INSTALLATION OF REPLACEMENT DSP BOARD IN 8 SLOT BACKPLANE.

70000467 1 4

TYPICAL MODIFICATION

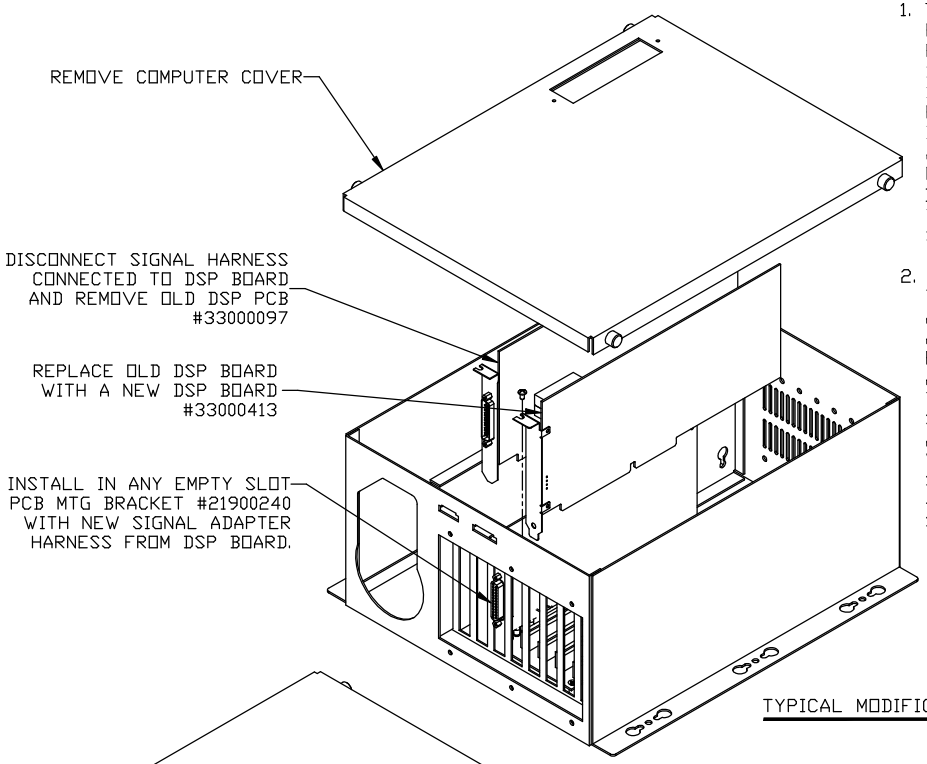
2. TYPICAL MODIFICATION TO BE USED WHEN A SPARE SLOT IS AVAILABLE. SEE SHT 2 FOR WIRING DIAGRAM. ALTERNATE MODIFICATION TO BE USED WHEN NO SPARE SLOTS ARE AVAILABLE. SEE SHT 2 WIRING IN AN 8 SLOT SYSTEM OR SHTS 3 AND 4 FOR WIRING IN 4 SLOT SYSTEM.
